## Plan Review Results

Comments in Red Box were previously provided as part of Foundation Permit.  
Comments in Blue Box are provided Feb 8, 2013, as part of New Building Permit.

## Summary of Comments on Building Department Notes and FEMA Map

Page: 2

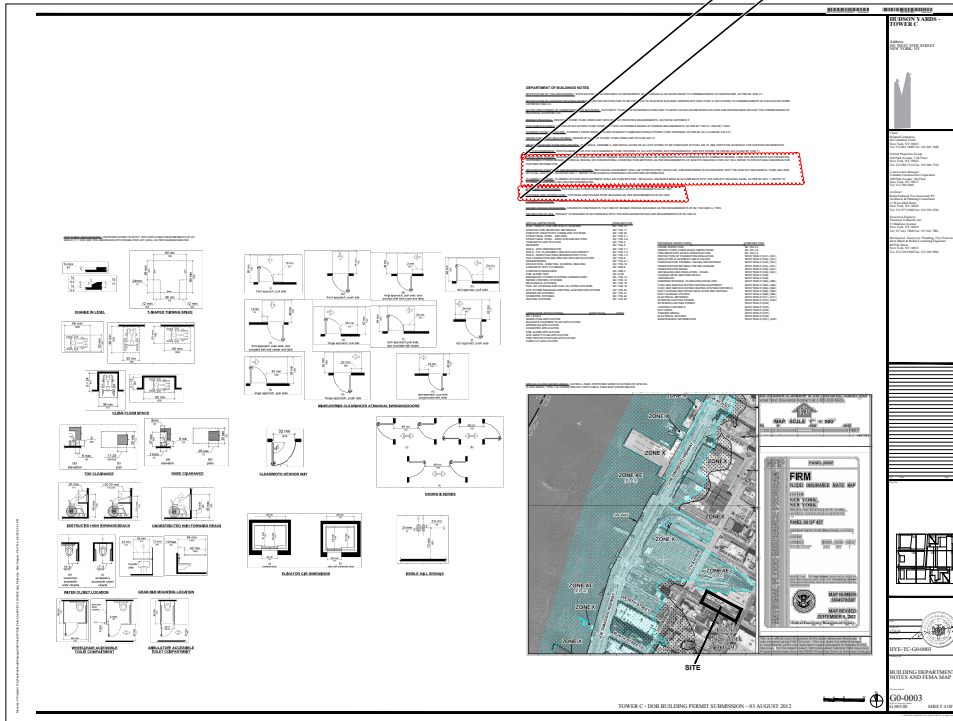
File separate applications for and indicate on plans;  
Sprinkler, 903 BC  
Standpipe, 905BC  
Fire alarm,  
Site safety plan - article 110  
Fire protection plan - article 109  
Curb cut.  
Emergency power systems (Generators)

\* Indicate occupancies as per occupancy group classifications of BC 302 and BC 508. Incidental use areas shall be classified as main occupancies to which they are incidental (BC 508.2). Accessory occupancies shall be individually classified in accordance with section 302.1 (BC 508.3.1.1).

\* BC 1301 Provide data sheet and state on plans, full compliance with NYC energy code.

\* List all progress inspections for energy code compliance on drawing.

\* Supporting documentation: building wall sections fail to detail insulation as continuous and/or cavity insulation to match the location and R value in the energy analysis.

\* Supporting documentation: door, window and skylight schedules fail to provide columns for u values for each exterior door, window and skylight type. If door, window and skylight types are drawn instead, with specifications included next to the respective drawing, u and SHGC values must appear with the other performance specifications for clarity and ease of contractor take-offs.

\* Supporting documentation: heating and cooling systems, including controls, are not provided such that they match the systems, equipment and performance criteria in the energy analysis.

\* Supporting documentation: plans fail to include reflected ceiling plans or lighting layouts on floor plans with fixture types and quantities, lamp wattages and quantities, space areas, sensors and controls to match those in the energy analysis for each room in the building.

\* Supporting Documentation: Building wall sections fail to show insulation to scale at the roof/ceiling, wall and/or at the foundation, slab-on-grade, basement or cellar to match descriptions in the Energy Analysis.

Author: dtitus Subject: Polygon Date: 9/6/2012 1:58:30 PM  
DOB drawing number should be the larger of the two number shown for DOB approval.

① NOTES ADDED TO B-SCAN DRAWING G-003.00

② NOTES ADDED TO B-SCAN DRAWING G-003.00

③ THE FOLLOWING SERIES WILL BE RESUBMITTED TO COMPLY:  
SOE  
STRUCTURAL  
ZONING  
ARCHITECTURAL (ONLY THOSE SHEETS WITH COMMENTS AT THIS TIME)

Page: 5

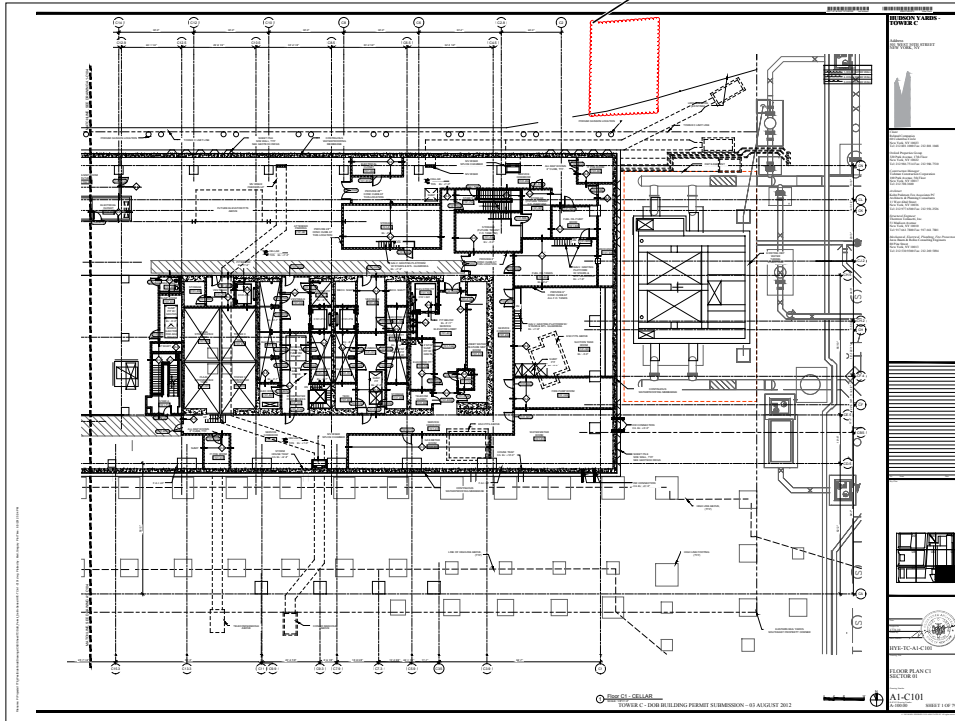
1. Propose building shall not be located closer than five feet to the edge of the ERY High Line and such five foot separation shall remain unobstructed, from the level of the High Line bed adjacent to such building to the sky. (Please provide additional information to verify compliance "Elevations, Sections, and Plan views with dimensions)

(2) Provide proper zoning exhibits for new enlargement as per memo 5/18/78.

Transit authority approval if required or provide note on plan "not within 200 feet of TA."

(5) BC 3306 Provide Demolition application

6 Builder's pavement plan filing.

7. Verify compliance with bicycle parking as per ZR 36-70. Fifteen square feet is required per bicycle parking space; commissioner approval is required if submission of a more efficient layout is provided.

8 Verify compliance with street tree planting for the entire zoning lot street frontage as per ZR 33-03. Indicate on plot plan.

Comply with TPPN 10/88 to avoid damage to historic landmark structures adjacent building (check all buildings 90' on each side of this address to find out whether or not). provide BIS print-outs with land book site area to verify on drawings, also indicate on plans showing compliance.

10 Show location of proposed construction fence on plot plan.

Provide restrictive declaration for building over hanging into separate tax lot. This must be recorded in the office of the city register.

(1) NOTES ADDED TO B-SCAN DRAWING Z-024.00.

(2) WILL BE SUBMITTED SEPARATELY.

(3) WILL BE SUBMITTED.

(4) NOTE ADDED TO B-SCAN DRAWING G-003.00.

(5) WILL BE PROVIDED.

⑥ BPP APPLICATION # ADDED TO B-SCAN DRAWING G-003.00.

(7) NOTE ADDED TO B-SCAN DRAWING Z-001.00.

⑧ TREE CALCULATIONS FOR ENTIRE ZONING LOT INDICATED ON B-SCAN DRAWING Z-001.00 AND FILED WITH PARKS DEPARTMENT. FORM ST-1 HAS BEEN FILED.

⑨ LANDMARK MAP ADDED TO B-SCAN DRAWING G-003.00 INDICATING NO HISTORIC STRUCTURES WITHIN 90'-0" OF SITE.

(10) FENCE ADDED ON PROPERTY LINE ON B-SCAN DRAWING Z-001.00.

11) LETTER FROM OWNERSHIP WILL ADDRESS COMMENT.

Page: 14

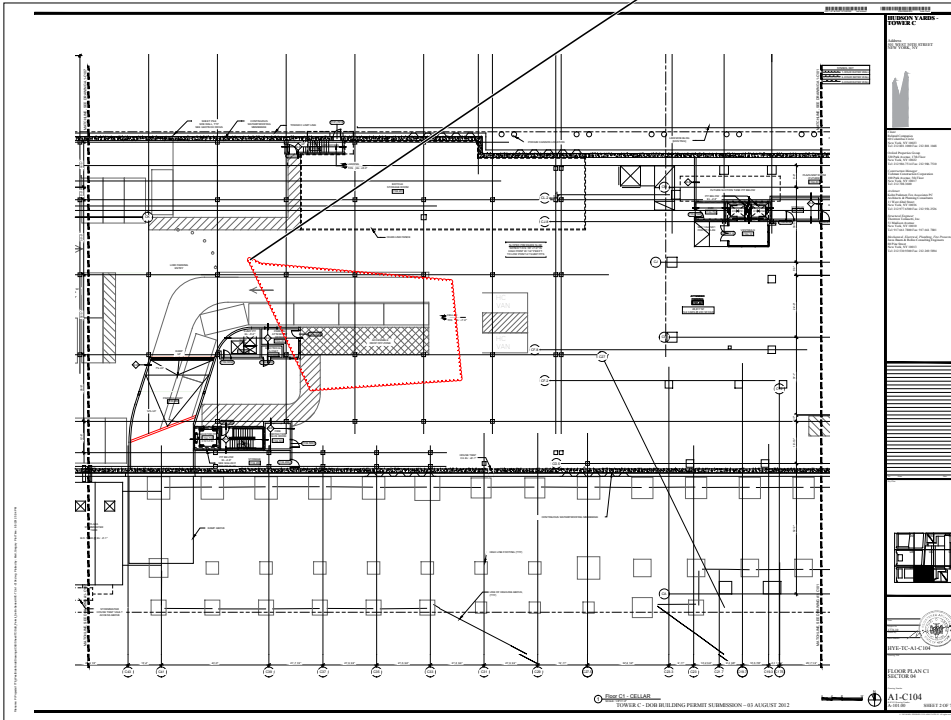
- 1 In an attended parking facility in which vehicles customarily are parked and later returned to their drivers by an attendant employed by the parking facility, accessible parking spaces need not be designated by a sign or lines if all of the following conditions are met:

- 2.1. Van-accessible parking spaces complying with Section 502 (Parking Spaces) of ICC A117.1 are provided;
  - 2.2. A passenger loading zone complying with Section 1106.7 is provided where an attendant shall take control of the vehicles. A vertical clearance of 98 inches (2489 mm) shall be permitted at such loading zone;

- 2.3. At least one accessible parking space shall remain available unless all accessible parking spaces are occupied;
  - 2.4. The attendant shall park and retrieve all vehicles not equipped with special controls entering the facility in which a person with disabilities is either the driver or a passenger, provided accessible parking space is available;

- 2.5. The attendant shall direct the drivers of vehicles equipped with special controls to accessible parking spaces. The attendant shall accompany such drivers to and from such space along an accessible route when they enter and exit the facility. If necessary, the accessible route and accessible parking space shall be created by the repositioning of vehicles parked previously by the attendant; and

- 2.6. Each van-accessible parking space shall have two permanently and prominently posted signs. One shall include the International Symbol of Accessibility complying with Section 703.6.3.1 of ICC A117.1. The other sign shall note that vehicles parked in such spaces are subject to being moved by an attendant of the parking facility in order to accommodate a vehicle which cannot be accommodated in another accessible parking space. Such signs shall not be obstructed by a vehicle parked in the space.

1 ABOVE DOB PARKING FACILITY NOTES ADDED TO B- SCAN DRAWING A- 101.00.

Page: 16

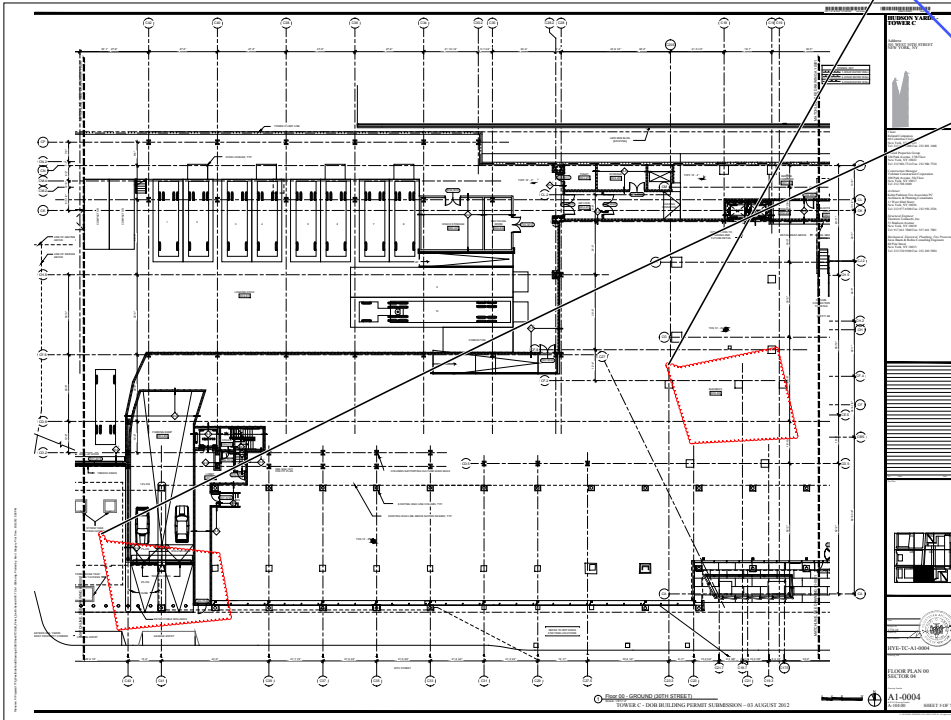
Author: dtitus Subject: Polygon Date: 9/7/2012 9:43:32 AM  
\* Provide exit lighting and directional signs (lighting) & (egress) as per BC 1006, BC 1011, BC 1026 (both EG and Construction plans) (TYP for all construction plans)

\* TABLE 403.1 TABLE 403.1 Provide table for plumbing fixtures to comply with table. 403.1. Provide calculations within each retail space, etc. and show layout to verify compliance to BC 1101.2; ICC/ANSI A117.1-2003

All nonresidential facilities to comply with BC 1109.

Show all grab-bars including vertical

Required clearance around the water closet to comply with ICC/ANSI 2003 604.3

Author: dtitus Subject: Polygon Date: 9/7/2012 10:33:52 AM  
\* Provide at least one elevator to accommodate 24"x76" ambulance stretcher (BC 3002.4).

Refer to EG-series and A-series for notes addressing exit lighting and directional signage for egress.

Refer to EG-series for plumbing fixture tables.

Note added to A-103 indicating accommodation of 24" x 76" ambulance stretcher.

Page: 18

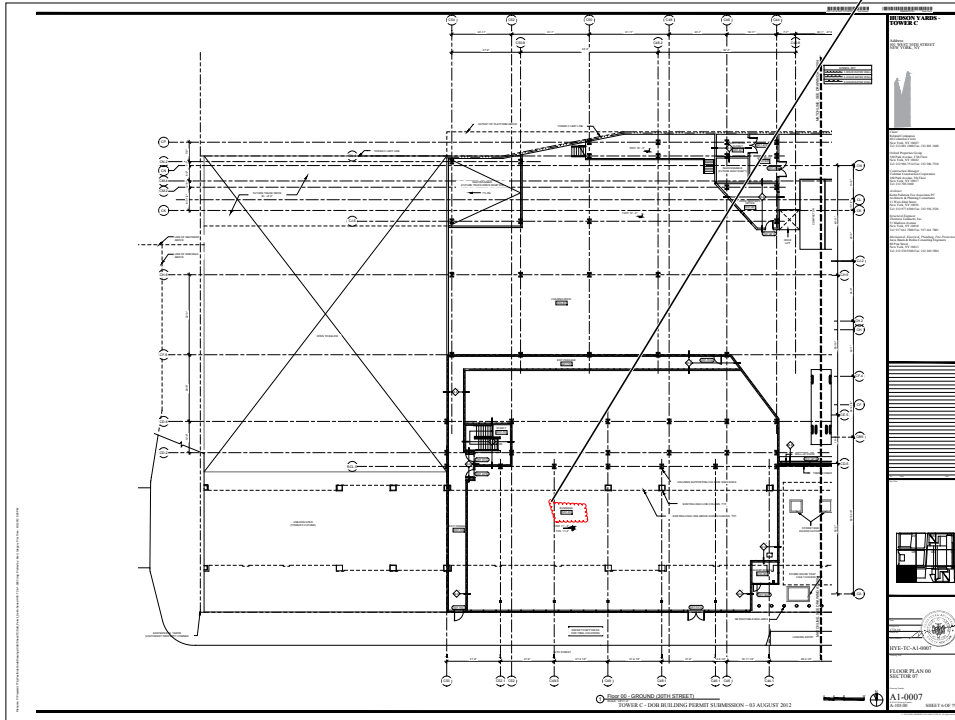
\* TABLE 403.1 TABLE 403.1 Provide table for plumbing fixtures to comply with table. 403.1. Provide calculations within each retail space, etc. and show layout to verify compliance to BC 1101.2; ICC/ANSI A117.1-2003

All nonresidential facilities to comply with BC 1109.

Show all grab-bars including vertical

Required clearance around the water closet to comply with ICC/ANSI 2003 604.3

Refer to EG-series for plumbing fixture tables.

Page: 27

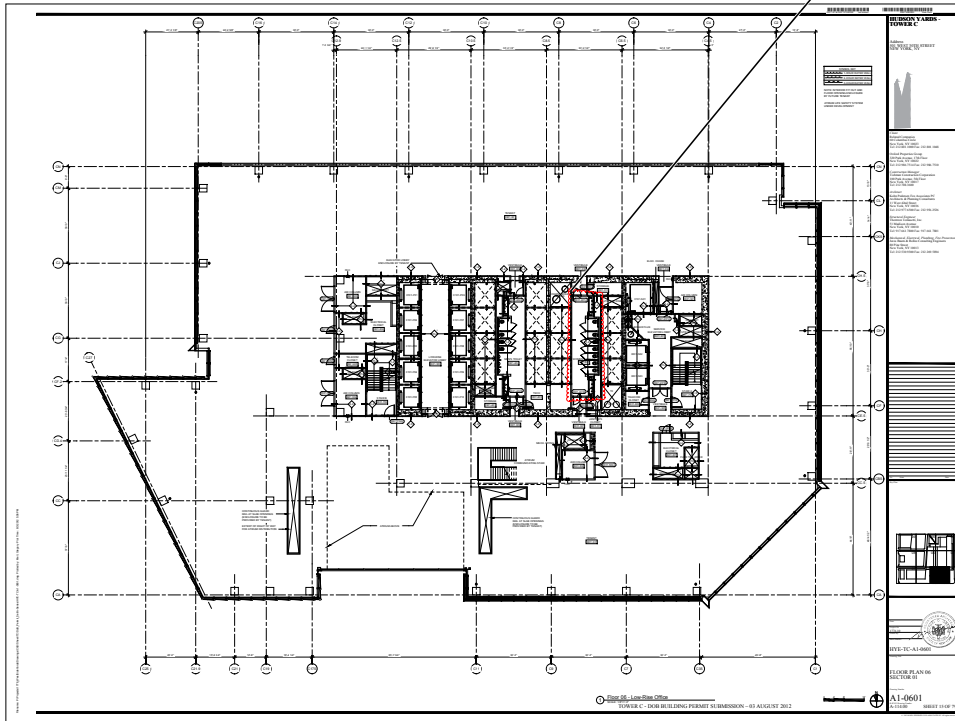
\* TABLE 403.1 TABLE 403.1 Provide table for plumbing fixtures to comply with table. 403.1. Provide calculations within each retail space, etc. and show layout to verify compliance to BC 1101.2, ICC/ANSI A117.1-2003  
All nonresidential facilities to comply with BC 1109.

Show all grab-bars including vertical

Required clearance around the water closet to comply with ICC/ANSI 2003 604.3

Elevator lobby enclosure is provided.

Provisions of BC 404 have been met. See Code Determination.

Page: 28

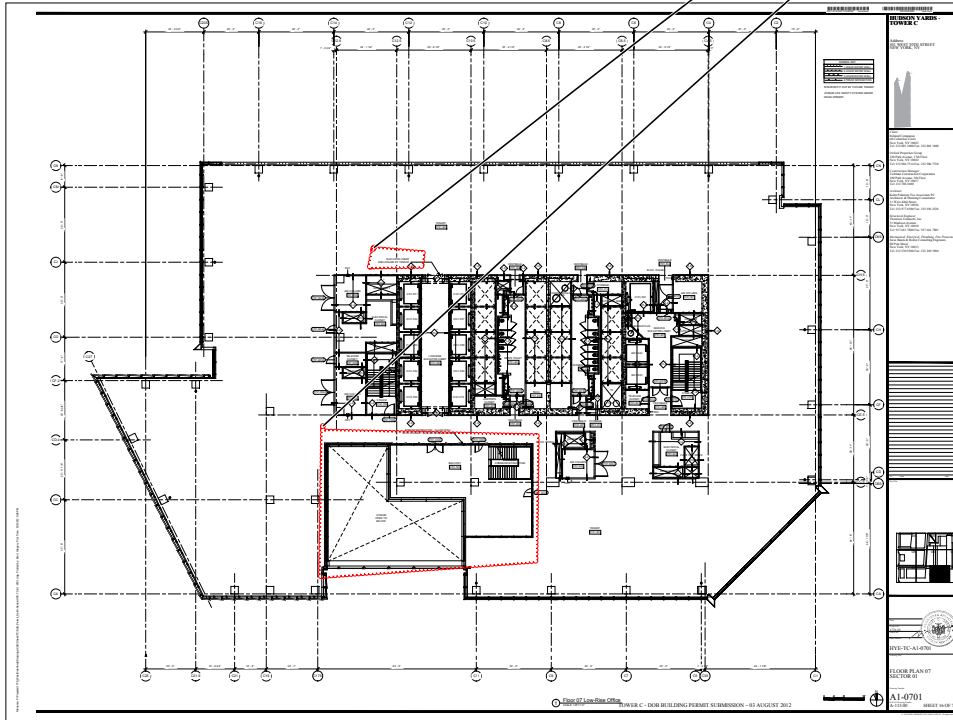
- \* Author: dtitus Subject: Polygon Date: 9/7/2012 9:58:12 AM
- \* Compliance with elevator enclosure must be completed under the NB application. TYP for all floors.
- \* Author: dtitus Subject: Polygon Date: 9/7/2012 10:16:38 AM
- \* Propose atrium to comply with BC 404.

2-hour atrium separation wall and details are called out on drawings are provided.

Page: 29

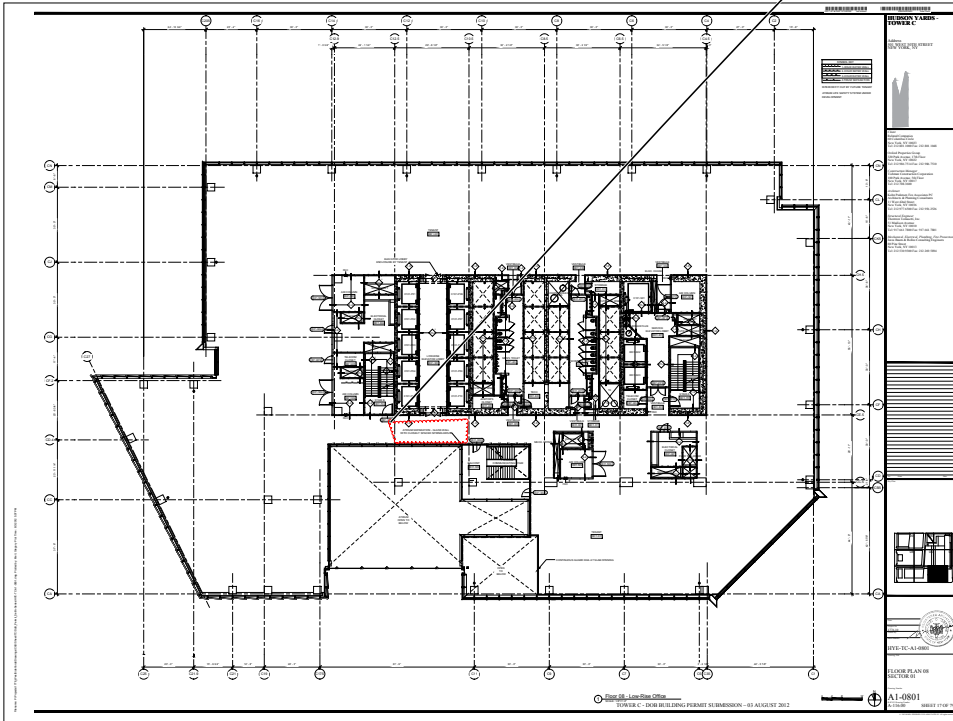
Atrium spaces shall be separated from adjacent spaces by a 2-hour fire barrier wall.

1. A glass or glass-block wall forming a smoke partition where automatic sprinklers are spaced 6 feet (1829 mm) or less along both sides of the separation wall, or on the room side only if there is not a walkway on the atrium side, and between 4 inches and 12 inches (102 mm and 305 mm) away from the glass and so designed that the entire surface of the glass is wet upon activation of the sprinkler system. The glass shall be installed in a gasketed frame so that the framing system deflects without breaking (loading) the glass before the sprinkler system operates.
2. The adjacent spaces of any three floors of the atrium shall not be required to be separated from the atrium where such spaces are included in computing the atrium volume for the design of the smoke control system.  
(Verify compliance)

A-series indicates "Office Tenant".

Page: 31

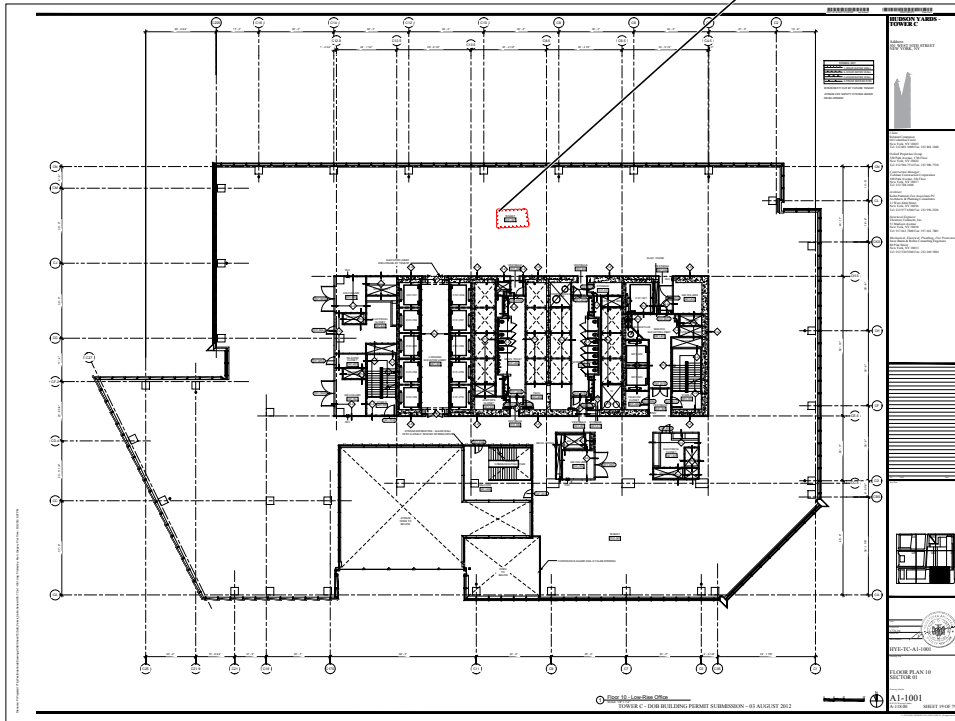
Author: dtitus Subject: Polygon Date: 9/7/2012 10:22:17 AM  
Please indicate tenant use also. (TYP for all floors)

Refer to note added to A-202.  
Refer to A-200 for approved CCD1.

Page: 77

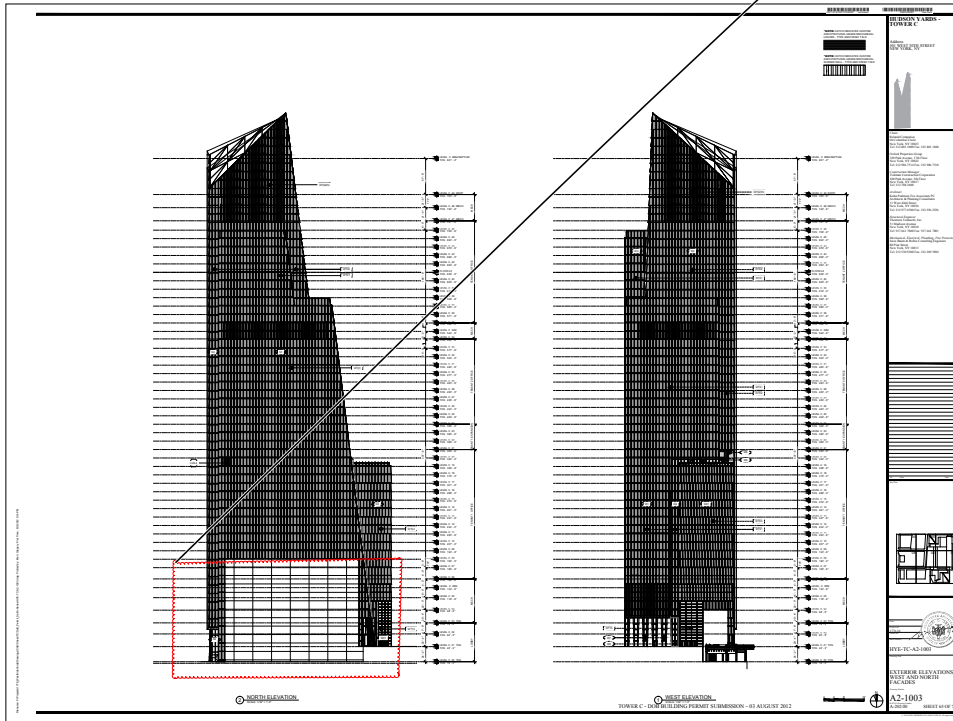
Author: dtitus Subject: Polygon Date: 9/7/2012 12:47:31 PM  
Provide fire protection of openings in exterior walls as per (BC 704.8, BC 705.8, BC 715.4).  
\* Provide restricted declaration. Declaration has to be recorded at the county clerk's office prior to approval.

Note added regarding compliance with Building Code Appendix Q.

Page: 80

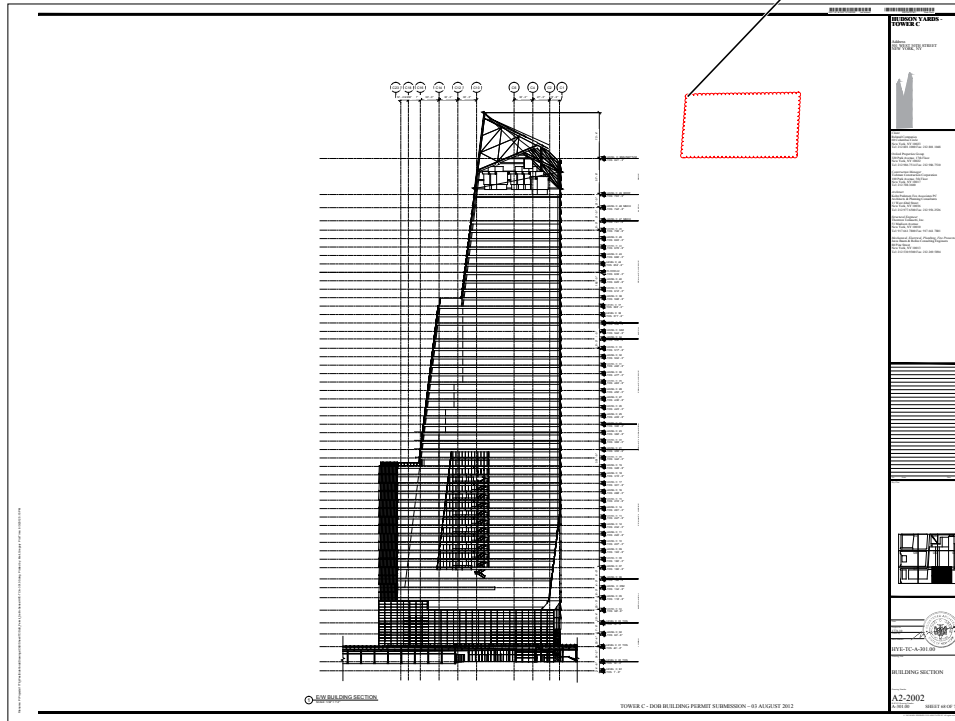
Author: dtitus Subject: Polygon Date: 9/7/2012 10:59:34 AM  
\* Show compliance with the requirements for elevator clearances (top & bottom) and runbys for cars and counterweight.

Area and occupant load summary have been provided on each EG-series plan.

Fire protection of openings not required. West 30th street is mapped 60' wide, with property line 30' from street centerline.
